INITIAL FIRE SAFETY INSPECTION REPORT

Masco Printing and Embroidery Ltd.

RSC ID: 24424

Date: 30-May-2022

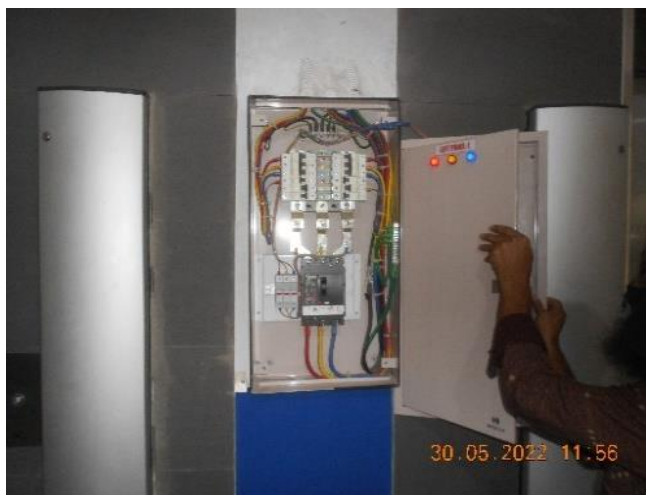
SI No.	Category	Findings	Required Action	Remediation Time Frame
F-06	Fire Rated Construction	Chemical storage area is not properly separated by fire-rated construction due to openings & penetrations. Location: On 2nd to 8th floor of building-1.	Separate the chemical storage room by 4-hr fire rated construction. Seal all penetrations and protect the openings to maintain the required fire separations for 4-hrs. Opening is not permitted for 4-hrs fire rated separation. Keep 16-points SDS of all chemicals in the storage area. Note: Construction type shall be Type-1 and separation shall be as per Table 3.2.1 of BNBC-2006.	Within 3 months
